# ADDENDUM 3

**PROJECT:**  
(IFB) #R-17-002-201  
**MIDDLE STREET OFFICE RENOVATIONS**  
City of Chattanooga

**ADDENDUM NUMBER:** 3

**DATE:** 10.10.17

EXPOSED WALL HYDRANT INSTALLATION DETAIL

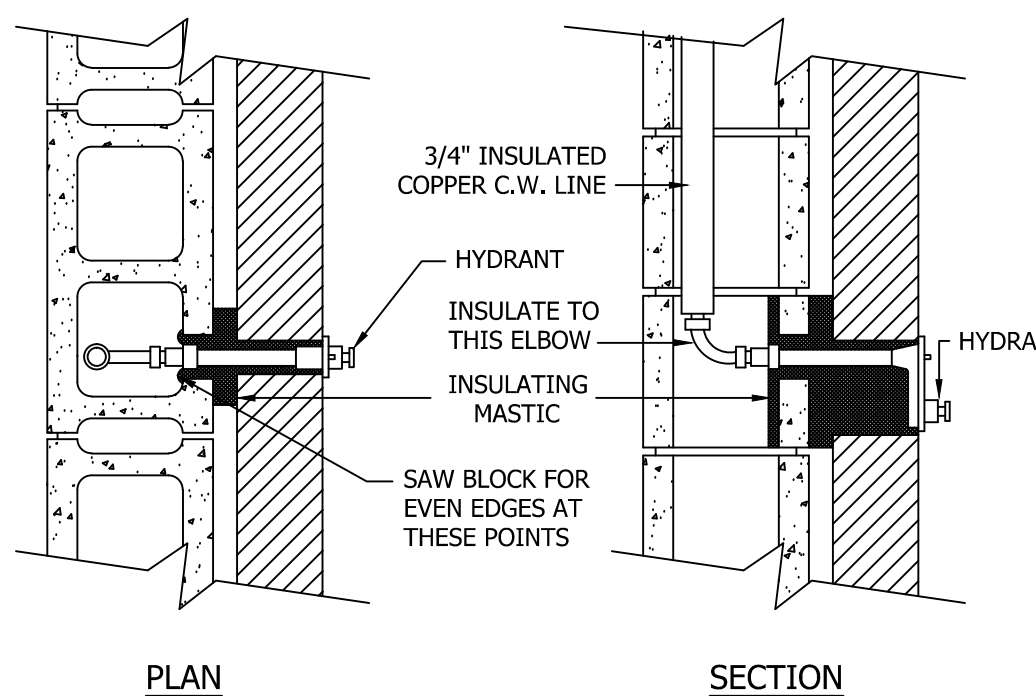
Exposed wall hydrant installation detail
